CITY OF OCEANSIDE

**Libby Lake Lighting and Mini Pitch Court
CIP23-00017**

ADDENDUM NO. 2

Section 8.12 Electrical Conduit for Mini Pitch Court Slab (Bid Item No.12):

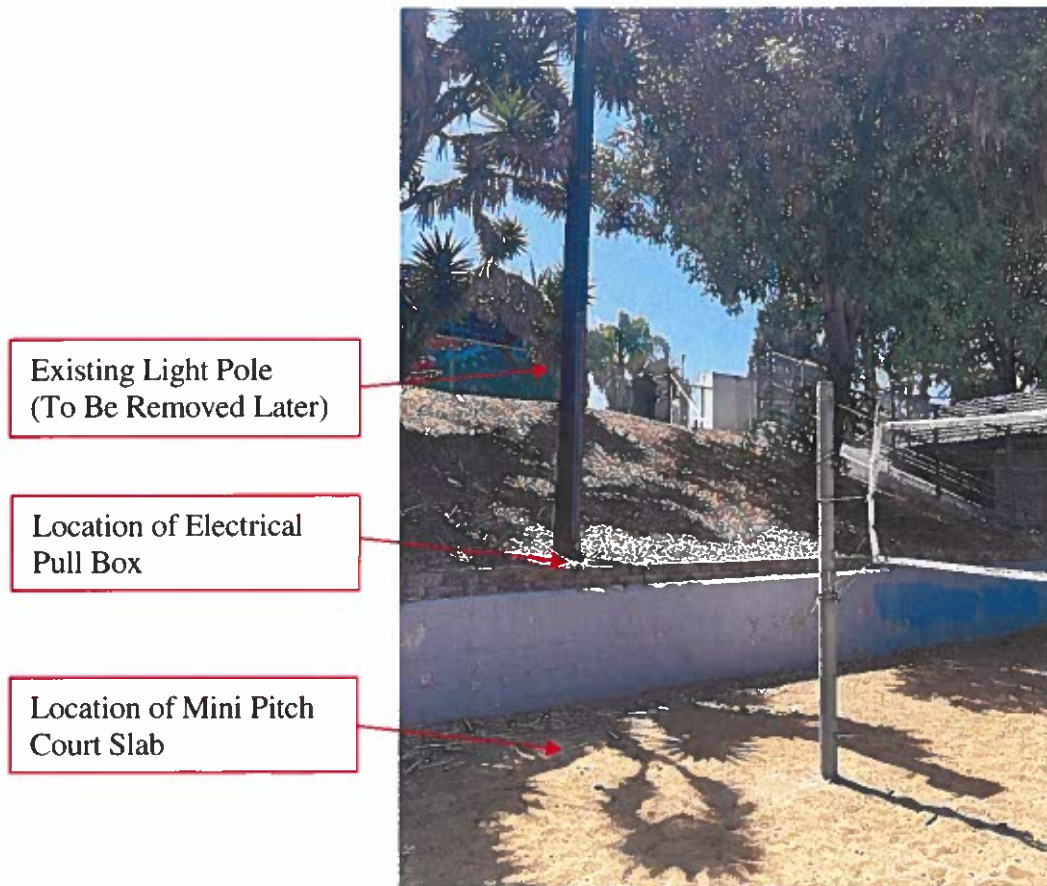
Replace:

All contents within Section 8.12.

With:

This bid item shall include full compensation for furnishing all labor, materials, tools, equipment, and incidentals and for doing all the working involved in trenching, backfill, and placement of empty electrical conduit and installation of an electrical pull box for the future mini pitch court lighting.

An electrical pull box shall be installed at the location of the existing lighting fixture as shown below in accordance with Section 701-11.1 of the Greenbook. It shall be noted that the existing lighting will be abandoned/removed at a later date and therefore, the existing lighting conduits that feed the existing pole shall be re-routed to the electrical pull box to allow for future connection to the empty electrical conduits that will be installed. Empty electrical conduits, capable of holding two circuits, shall be installed from the newly installed electrical pull box to the western edge of the slab in accordance with Attachment B and Section 701.12.1 of the Greenbook.

The location of the existing light pole referenced above is shown below:
